ONSITE SEWAGE DISPOSAL SYSTEM

PROPERTY ADDRESS: 14290 Triadelphia Road

From: Williams, Jeffrey
Sent: Monday, February 02, 2015 3:16 PM
To: 'Stephanie Tuite'
Subject: RE: Homewood Interiors BAT (14290 Triadelphia Rd)

SDP-15-010

14290 TRADEPHIA ROAD
PARCEL NO. 135
FOURTH ELECTION DISTRICT HOWARD COUNTY, MARYLAND
DATE: FEBRUARY, 2015
SHEET 5 OF 5

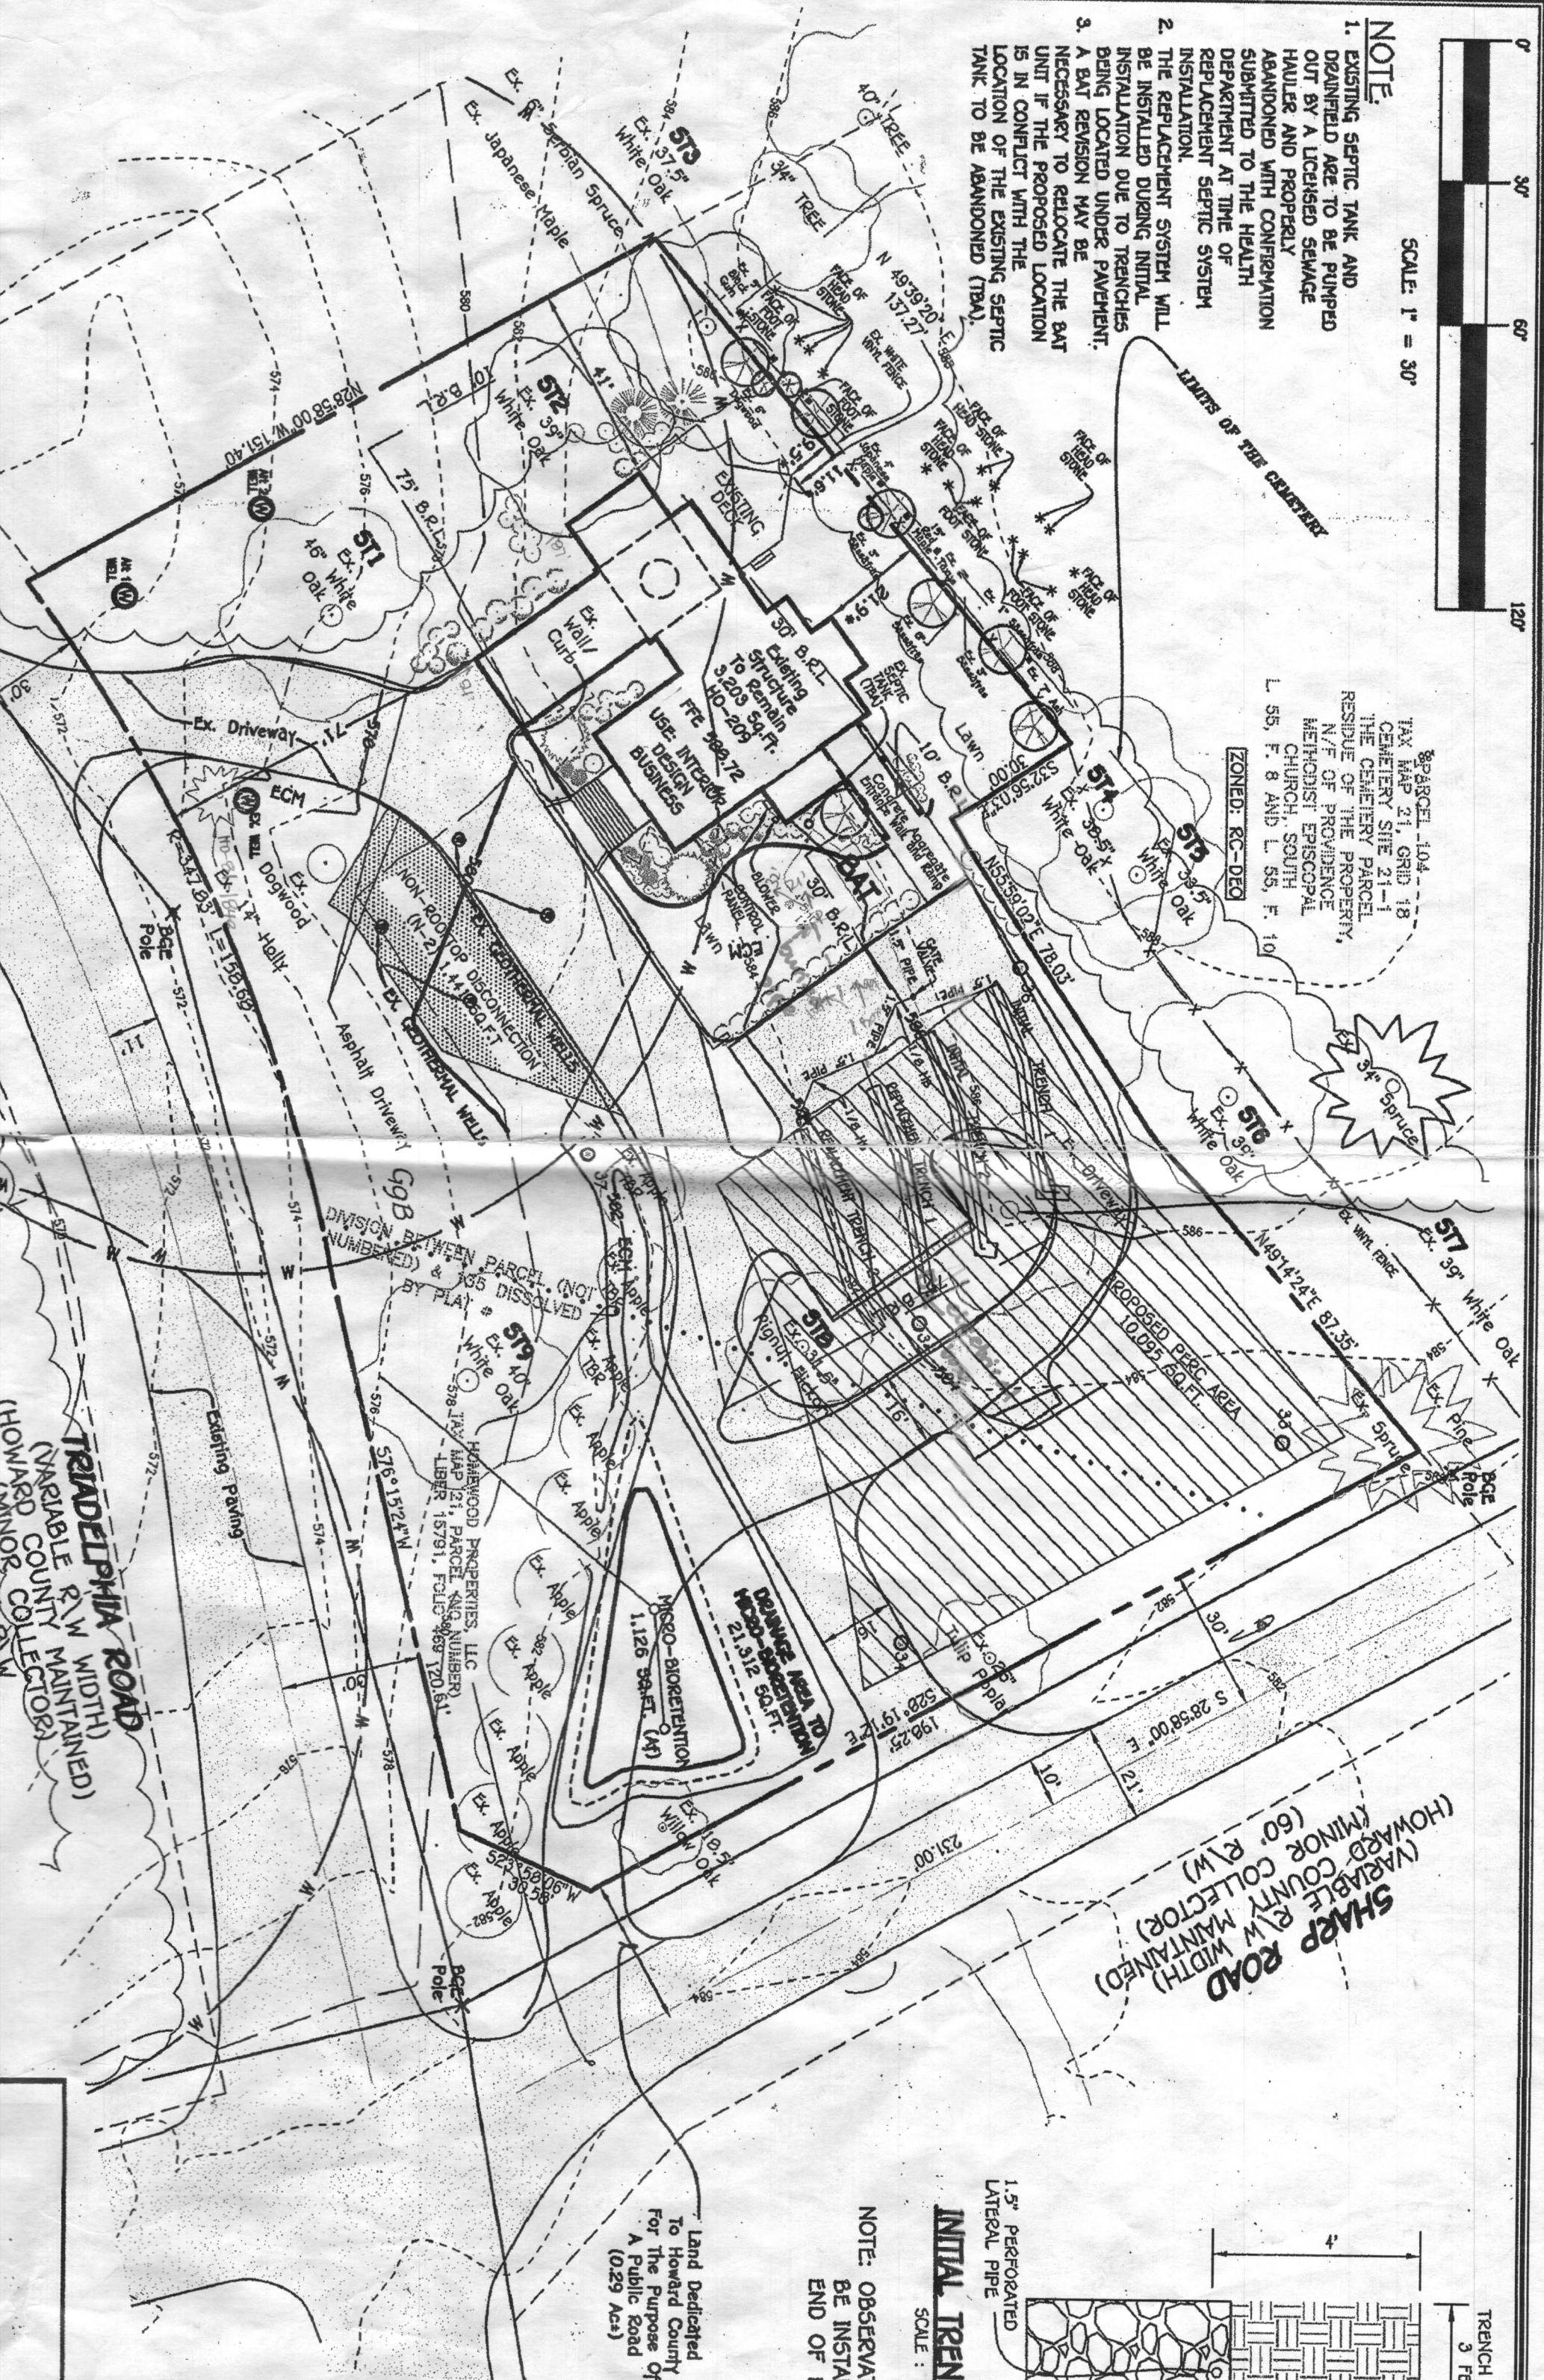
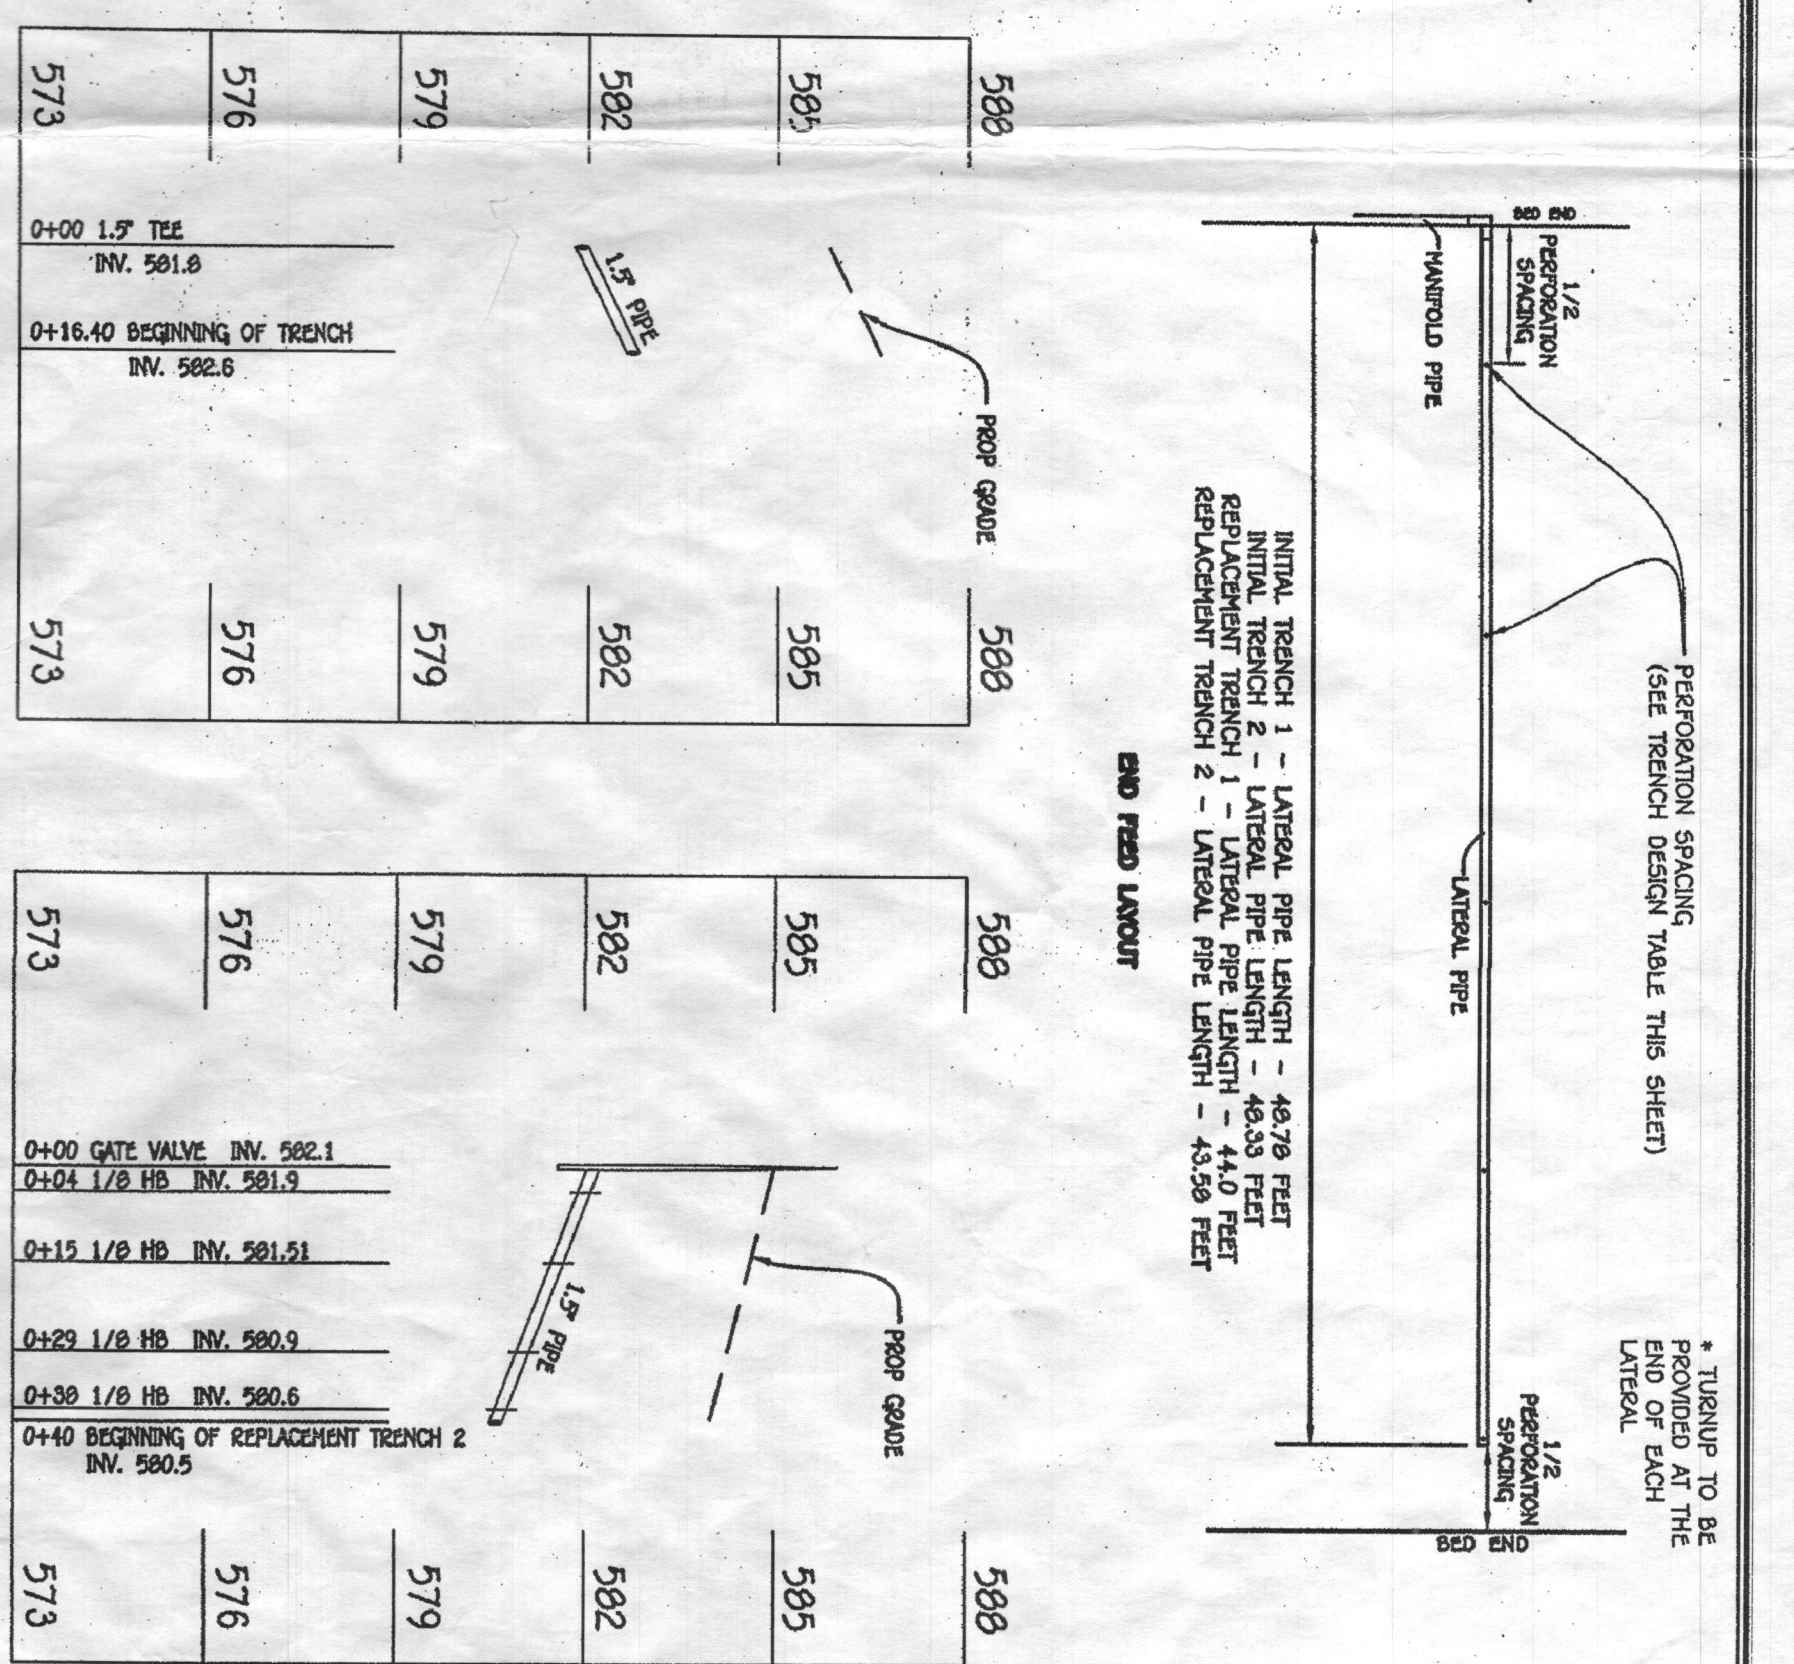
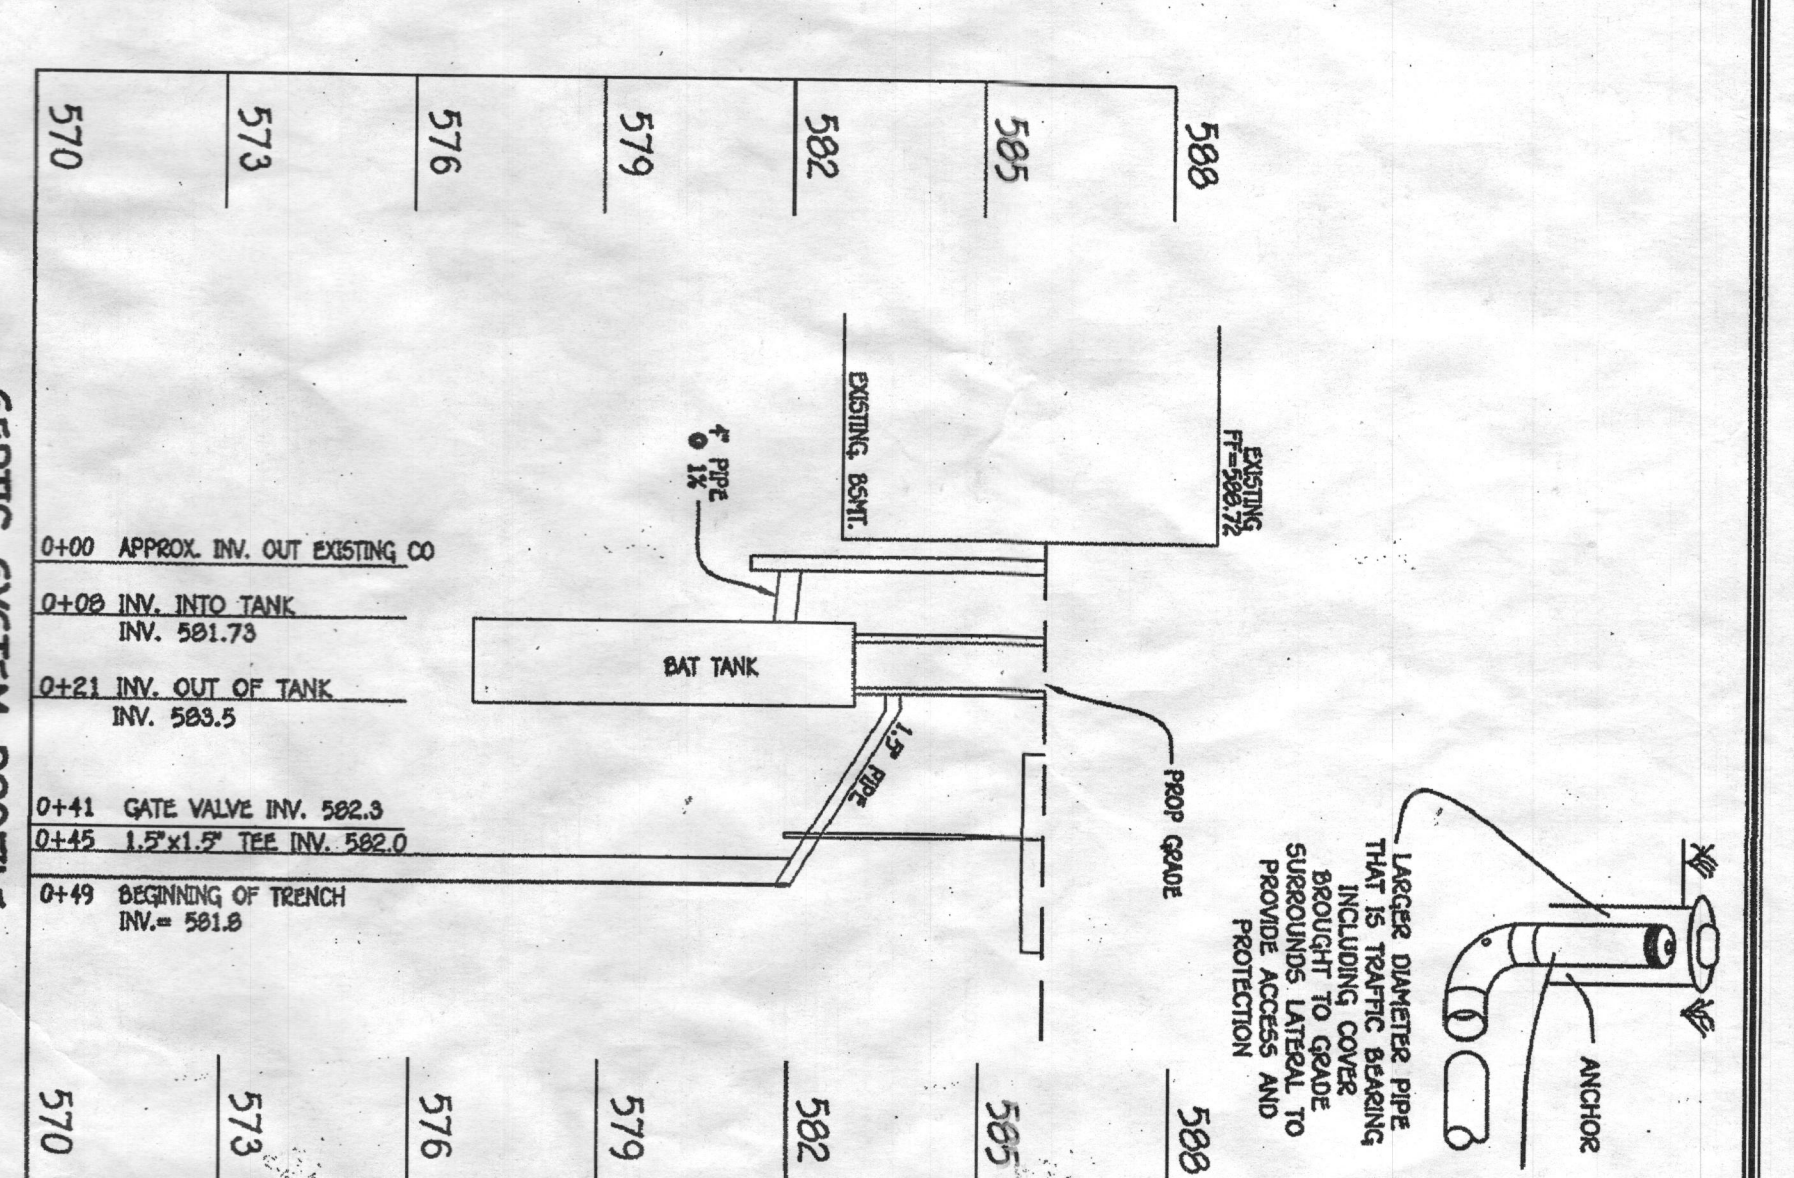
- Static head is elevation difference between pump off float/probe and the highest point in the piping system. The highest point is the invert out of the tank, which you give as 583.5. You give the pump off as 578.56. That puts the static head at 4.94'

- You state friction loss in 2" pipe fittings, but you list all piping at 1.5" diameter.
- You give a volume of 1.25" pipe for the laterals when calculating dose, but elsewhere you show the laterals at 1.5" diameter.

- You show perf spacing in trench 1 at 4.25' with 11 perfs. That gives a lateral length of 44.625, not 48.9 as stated (10 spaces at 4.25' and one half space at 2.125'). This is too short for the trench length at 51'. A spacing of 4.25 could accommodate 12 holes in a 51' trench with a lateral length of 48.875. All other trenches have similar problems.

- An adjustment for the number of perfs will correspond to an increase in the total flow rate for the system.
- The pump run time should be set to correspond to the revised flow rate.

- Show the location of the blower motor and the control panel on the plan.

The perf spacing and lateral length are incorrect based on the info provided.

T1 length 51' with 11 holes should be: 4.636' spacing and 48.68' lateral length
T2 length 51' with 9 holes should be: 5.66' spacing and 48.17' lateral length
T3 length 46' with 11 holes should be: 4.18' spacing and 43.91' lateral length
T4 length 46' with 9 holes should be: 5.11' spacing and 43.445' lateral length

Markup Name	Markup Text	Markup Date	File Name	First Name	Last Name
Jeff Williams	lateral length and perforation spacing is not correct for all trenches based on number of perforations and length of trench provided.	02/20/2015	SDP-15-010 Sheet 5.dwf	Jeff	Williams
Jeff Williams	static head note should state "pump off to highest point in distribution network".	02/20/2015	SDP-15-010 Sheet 5.dwf	Jeff	Williams
Jeff Williams	Add note stating that a BAT plan revision may be necessary to relocate the BAT unit if the proposed location is in conflict with the location of the existing septic tank to be abandoned.	02/20/2015	SDP-15-010 Sheet 5.dwf	Jeff	Williams
Jeff Williams	Include a Health officer signature block on all pages.	02/13/2015	SDP-15-010 Sheet 1.dwf	Jeff	Williams
Jeff Williams	label existing septic tank as to be abandoned	02/13/2015	SDP-15-010 Sheet 2.dwf	Jeff	Williams
